# UNITED STATES PATENT AND TRADEMARK OFFICE

APPLICATION NO.	FILING DATE	FIRST NAMED INVENTOR	ATTORNEY DOCKET NO.	CONFIRMATION NO.
10/731,612	12/09/2003	Jeffrey M. Dils	10710-623(PTG 0633 PUS2)	4771
757	7590	11/13/2006	EXAMINER	
BRINKS HOFER GILSON & LIONE P.O. BOX 10395 CHICAGO, IL 60610			NGUYEN, PHONG H	
			ART UNIT	PAPER NUMBER
			3724

<b>Office Action Summary</b>	Application No. 10/731,612	Applicant(s) <sup>NC</sup> DILS ET AL.	
	Examiner Phong H. Nguyen	Art Unit 3724

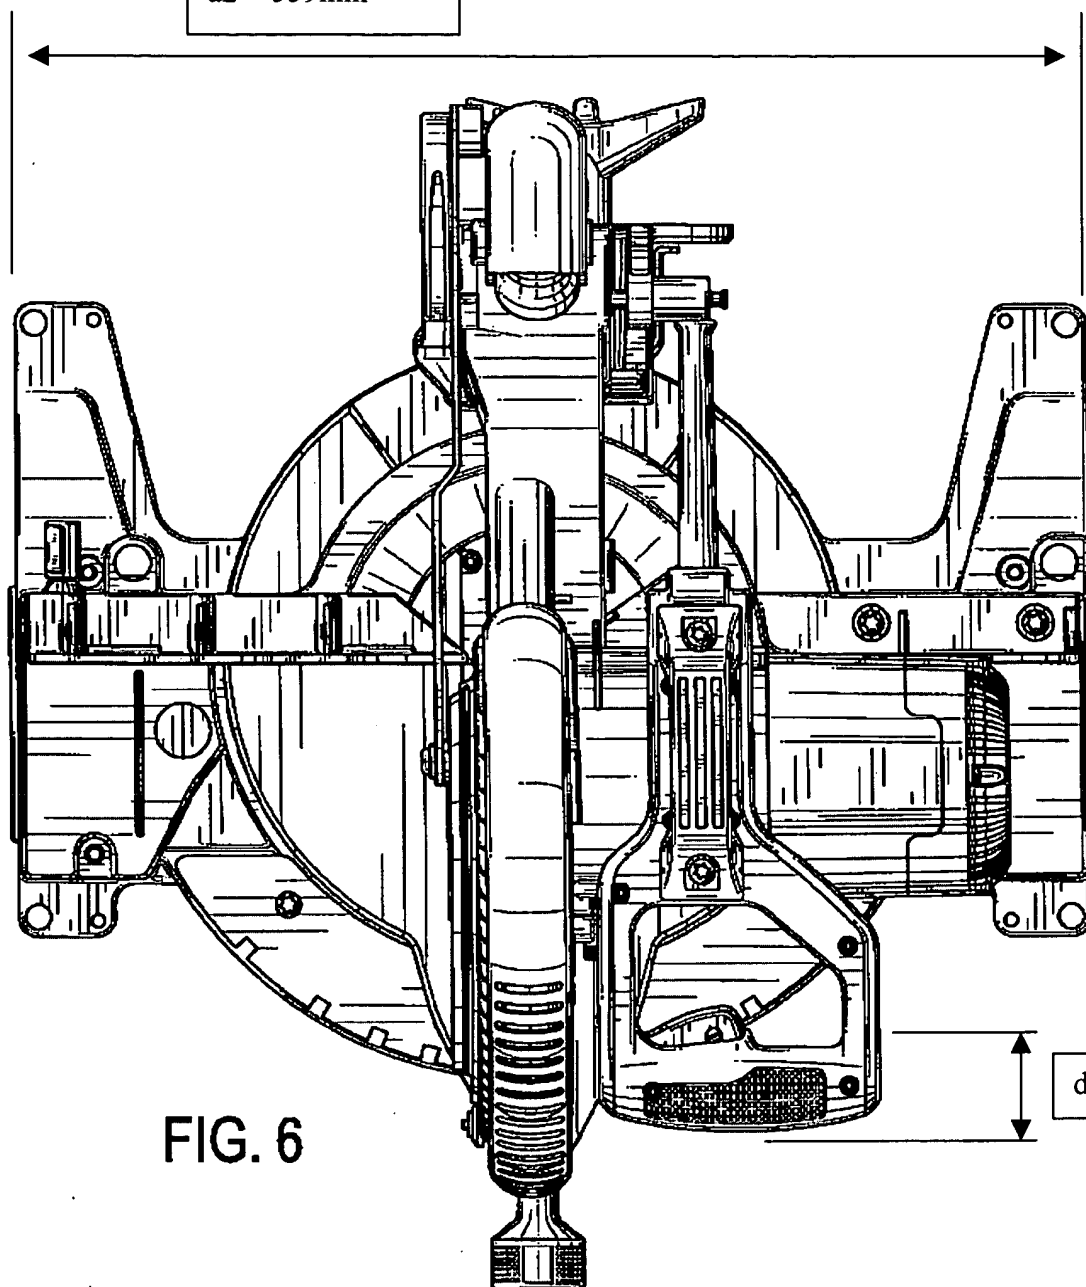
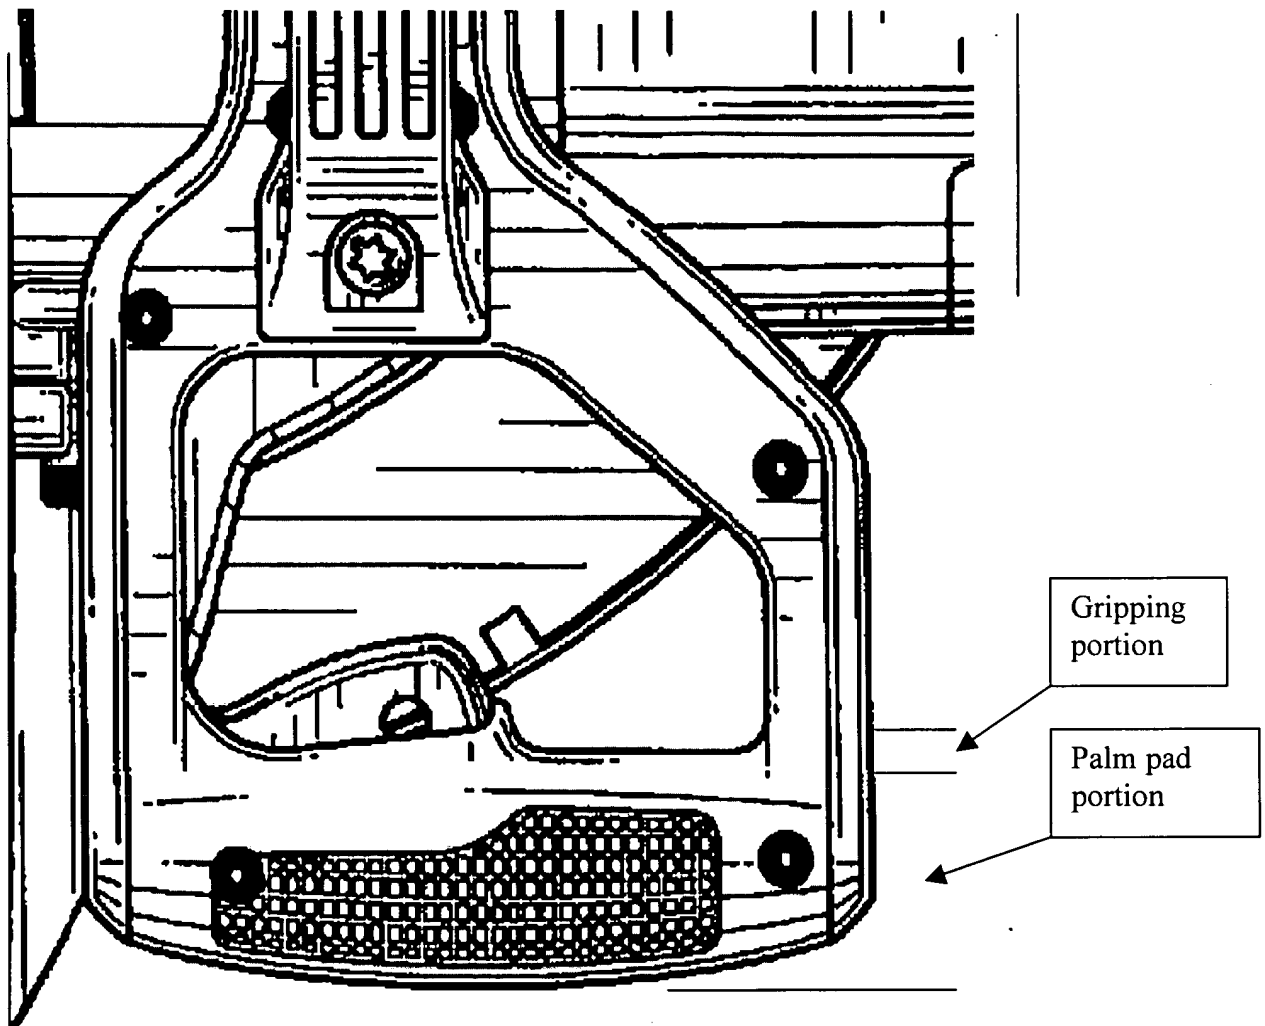
The distant (a1) in Fig. 6 is 120 mm. The distant (a2) of a real miter saw is about 559mm, which is 22 inches. Therefore, the scale of Fig. 6 with respect to the real miter saw is  $a1/a2 = 120/559 = 1/5$ .

Having the width of the handle being  $d1 = 10$  mm and the scale being  $1/5$ , the distant (d2) of a real miter is  $10 \text{ mm} \times 5 = 50 \text{ mm}$ , which is 2 inches.

The length of a palm of an adult person is 3-4 inches. The heel portion as defined in Fig. 3 of the Applicant's disclosure is  $3/4$  the length of the palm measured from the base of the fingers to the wrist. Therefore, the heel portion has a length about 3

inches. Since the Bean's handle extends into the palm's area defined as the heel portion,

Bean meets the limitation (c).
